STATE OF NEW YORK
OFFICE OF GENERAL SERVICES
DESIGN AND CONSTRUCTION GROUP
THE GOVERNOR NELSON A. ROCKEFELLER
EMPIRE STATE PLAZA
ALBANY, NY 12242

ADDENDUM NO. 1 TO PROJECT NO. 45060
REPAIR / REPLACE ROOF
DOT Region 1, Waterford
182 Davis Avenue
Waterford, NY

August 13, 2014

DRAWING NUMBER:
A-104

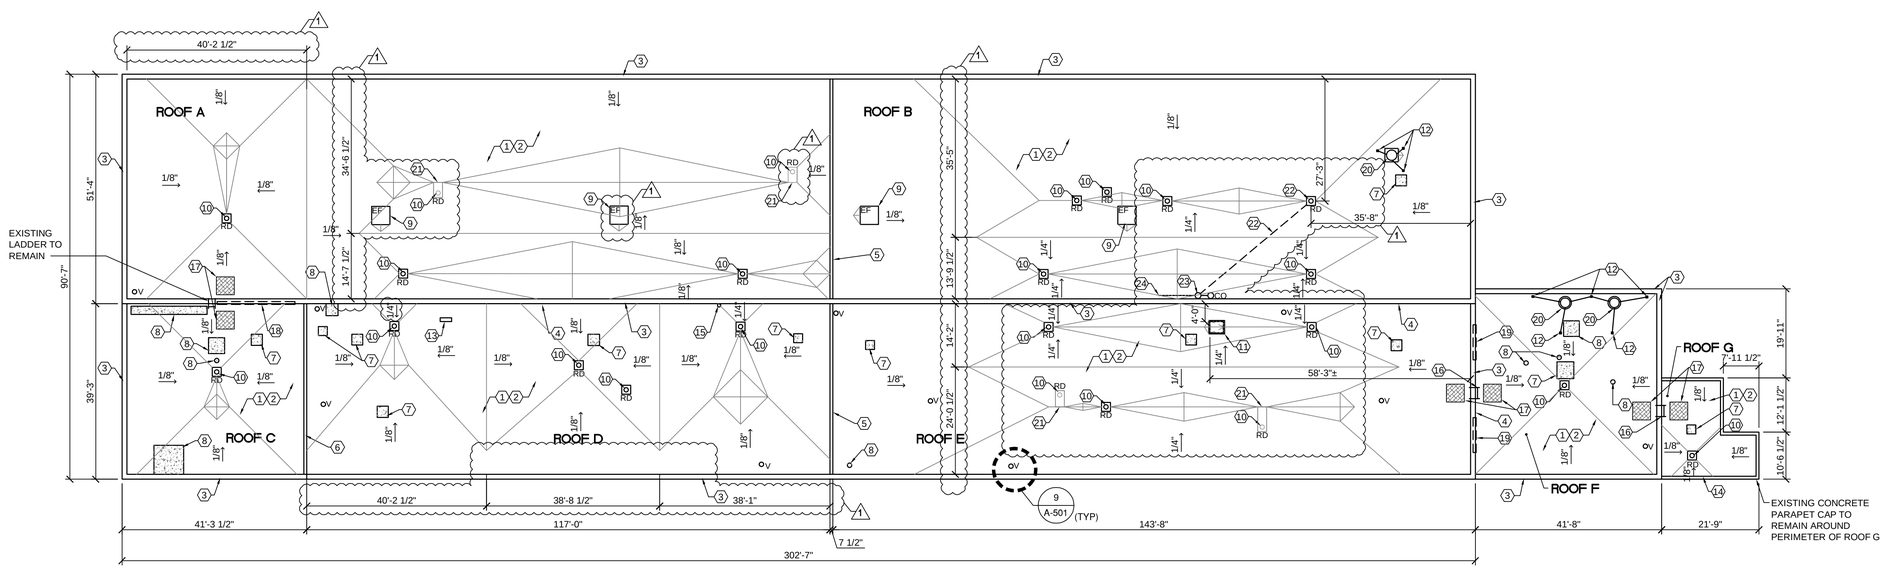
7. Revised Drawing:
   a. Drawing Nos. A-104, A-501, A-502 and A-503, noted Mark "1", Date "8/12/14", Description "ADDENDUM #1" accompany this Addendum and supersede the same numbered originally issued drawings.
